UNITED STATES PATENT AND TRADEMARK OFFICE

| APPLICATION NO. | FILING DATE | FIRST NAMED INVENTOR | ATTORNEY DOCKET NO. | CONFIRMATION NO. |
|---|-------------|------------------------|--------------------------------|------------------------|
| 10/696,583 | 10/30/2003 | William J. Farrell JR. | 548.0001 | 7235 |

| Office Action Summary | Application No. 10/696,583 | Applicant(s) FARRELL ET AL. | |

DETAILED ACTION

Figure 6 from Sacks

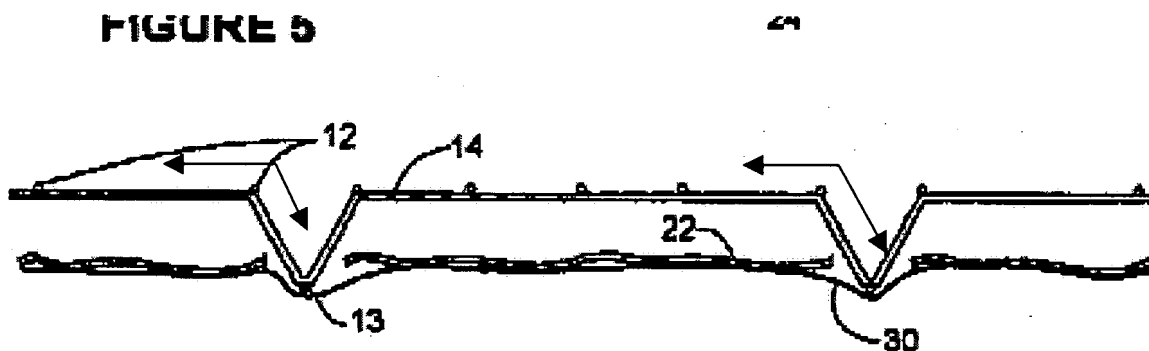
Claim 5: while the ridges in Chen in view of Sacks are V-shaped (see Figure 1, below for clarification), and have a depth of about $\frac{1}{2}$ inch (Col. 7, lines 3 and 4), the specifics of the dimensions of the width of the panel. It would have been obvious at the time the invention was made to a person having ordinary skill in the art as a matter of design choice to have these dimensions because Applicant failed to state a criticality for the necessity of these limitations and the prior art of record is capable of conforming to the limitations.

Claim 6: Chen in view of Sacks discloses 2 parallel V-Shaped impressions (see above) defined in at least the outer wire mesh member.

Claim 10: Chen in view of Sacks discloses an outer layer (Chen: Claim 8), but not that the V-shaped impressions are used as a screed. It would have been obvious at the time the invention was made to a person having ordinary skill in the art to use the V-shaped impressions (see above) as a screed in order to prevent the waste of stucco applied to the surface.
